**STAFF REPORT**

SUBJECT: H-2021-0051  
Burger King Drive-Through – CUP

LOCATION: The site is located at 6211 N. Ten Mile Road, on the west side of N. Ten Mile Road, approximately 500 feet south of Chinden Boulevard (Lot 11, Block 1, Lost Rapids Subdivision), in the NE ¼ of the NE ¼ of Section 27, Township 4N., Range 1W.

### A. Proposed Site Plan (dated: 9/03/2021)

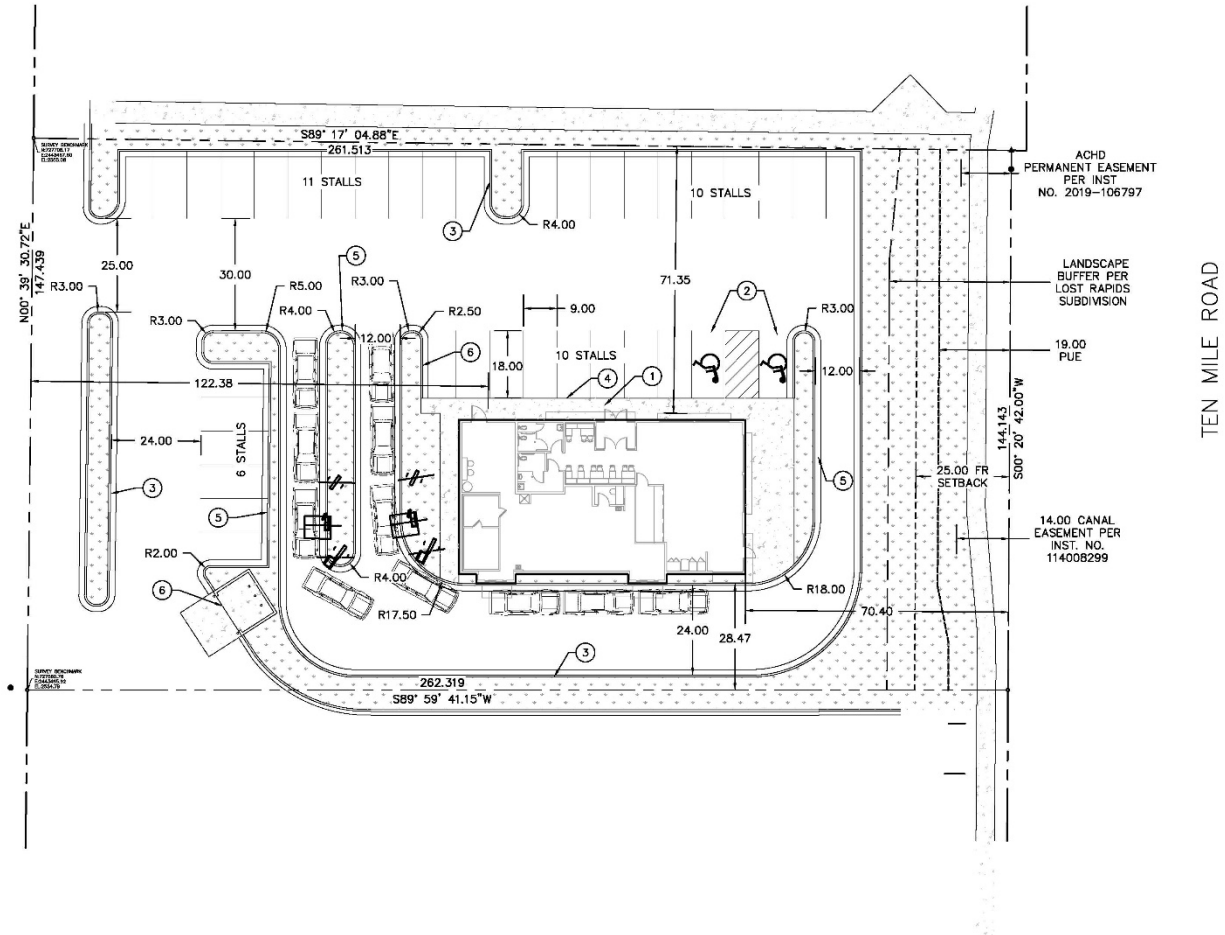
*The proposed drive-through has two ordering menu boards with stacking for approximately three (3) vehicles per lane, according to the submitted site plan. Each stacking lane is approximately 60’ deep from the edge of the 30’ wide drive aisle that is proposed as the main access to the future building and the drive-through exit in the north end of the site. The proposed 30’ drive aisle is 5’ wider than required by code which allows some relief if stacking backs up into the drive aisle while ordering. The total stacking length is approximately 128’ from the edge of the drive aisle to the pick-up window along the south side of the building; this allows at least 7 vehicles to stack according to the submitted site plan.*

*Per the submitted site plan, the stacking lanes are off of the northernmost drive aisle and provide at least 120’ of stacking with each menu board location and approximately 128’ in total to the pick-up window before any vehicle would impede this drive aisle. No parking is impeded by the proposed stacking lanes and nor would any be should stacking exceed the proposed depth because of the site design.*

*The stacking lane exceeds 100' in length from the drive aisle to the pick-up window. Therefore, the Applicant has proposed an escape lane adjacent to the drive through lane along the southern boundary. This escape lane configuration meets this standard.*

*The drive-through is not directly adjacent to the nearest public street (N. Ten Mile Road) along the east boundary of the site but the south boundary of the site and the pick-up window is still visible from Ten Mile. To help meet this standard, Staff is recommending revisions to the landscape plan to remove some of the proposed landscaping that would obstruct the line of sight from the street to the pick-up window as currently proposed. If this cannot occur or would incur undue costs because the street landscaping is already in place, there is ample surveillance opportunity from within the commercial subdivision and internal drive aisles.*

**Pedestrian Walkways:** No pedestrian walkway is depicted on the site plan from the arterial/perimeter sidewalk along N. Ten Mile Road to the main building entrance. UDC 11-3A-19B.4a requires this connection for all nonresidential uses. Therefore, Staff is recommending a

1. Future development of this site shall comply with the existing Development Agreement (Inst. #[2018-079970](#), Lost Rapids - GFI Meridian Investments II, LLC) and associated conditions of approval (H-2018-0004; FP-2019-0056).
2. The site plan submitted with the future Certificate of Zoning Compliance application shall be revised as follows:
  - a. Depict a pedestrian walkway from the sidewalk along N. Ten Mile Road to the building entrance near the drive-through exit. Construct the pedestrian crossing of the drive-through, or any other pedestrian facility that crosses a vehicular use area, with a different material—stamped or colored concrete, brick pavers, or similar are acceptable forms of meeting this requirement per [UDC 11-3A-19B.4b](#).

## B. Proposed Landscape Plan (dated: 7/08/2021)

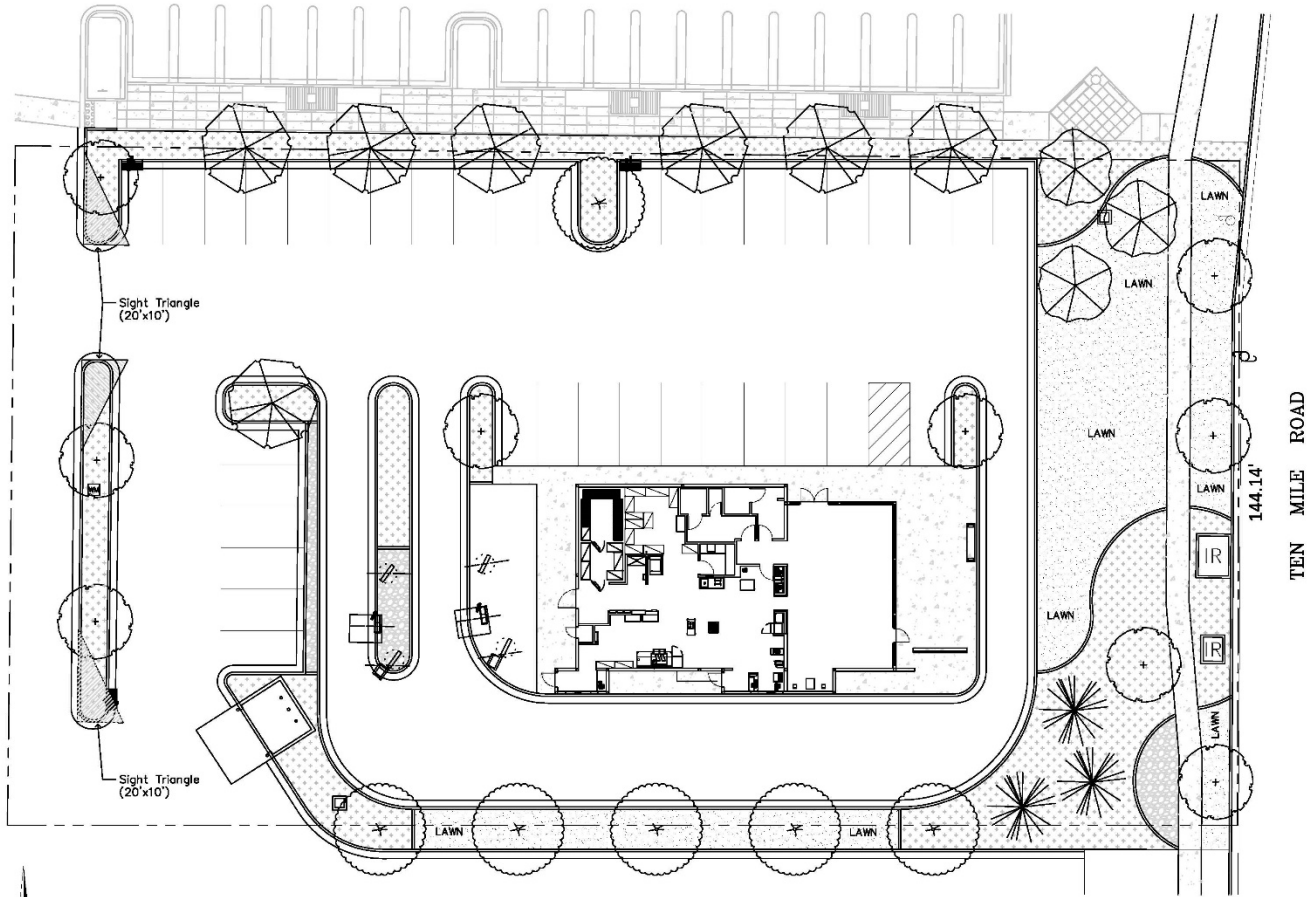
Street buffer landscaping, including a sidewalk, along N. Ten Mile Rd. was installed with development of the overall subdivision. The submitted landscape plans show a majority of this buffer remaining as it currently exists but Staff is recommending that the southern portion of the site have some of the trees removed to increase visibility from Ten Mile to the pick-up window. If the trees can be relocated to other areas of the site, Staff supports this.

3. The landscape plan submitted with the future Certificate of Zoning Compliance application shall be revised as follows:
  - a. Depict the required pedestrian walkway as noted above, per UDC 11-3A-19B.4a and UDC 11-3A-19B.4b.

- b. Revise the layout or reduce the number of trees shown in the southeast corner of the arterial street buffer to increase visibility from N. Ten Mile Road to the pick-up window and drive-through lane.
